HGY/2024/0715 45 Cholmeley Crescent

Louise Lewis
For Highgate Conservation Area Advisory Committee

Of course the drawings included 2247-160 Landscape Plan.

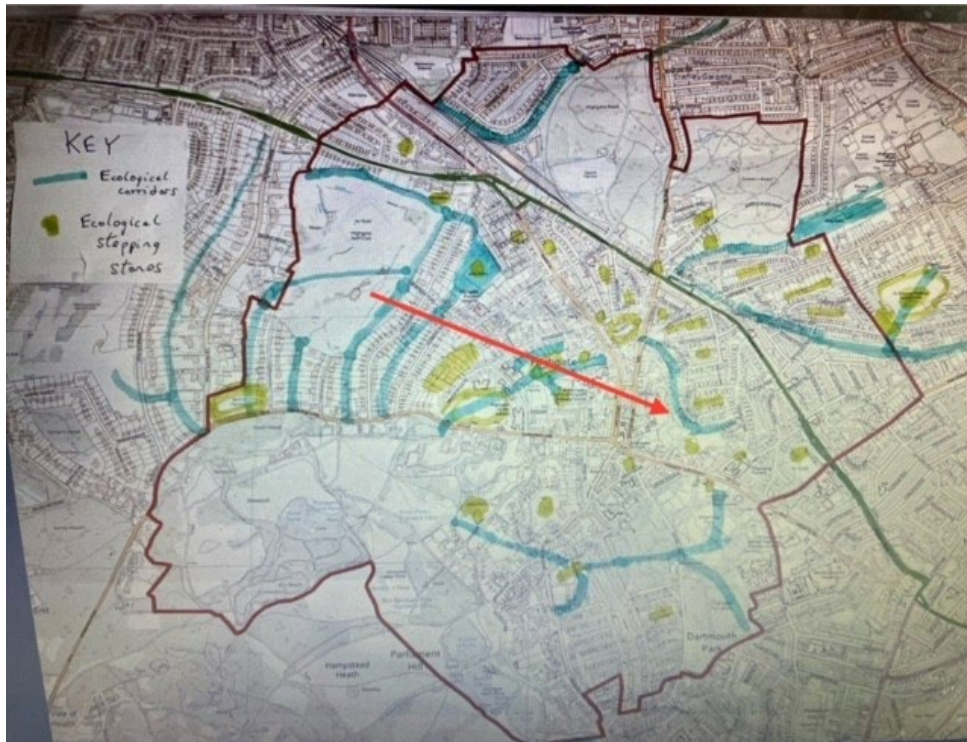
If the applicant is given permission to t go ahead with this project, they will have broken condition 2 for HGY/2023/2613.

That cannot be right.

This is application is virtually the same as that part of previous refused one, HGY/2023/1684, except that the roof is slightly lower.

There is no reference to trees and habitat, no assessment of the impact on trees and habitat in the area.

Please note that this back garden forms part of an ecological corridor in Appendix 3 attached to the HNP. The Highgate Neighbourhood Forum is currently refining and updating the map, which is contributing to the emerging Haringey Local Plan.

This application should be rejected.
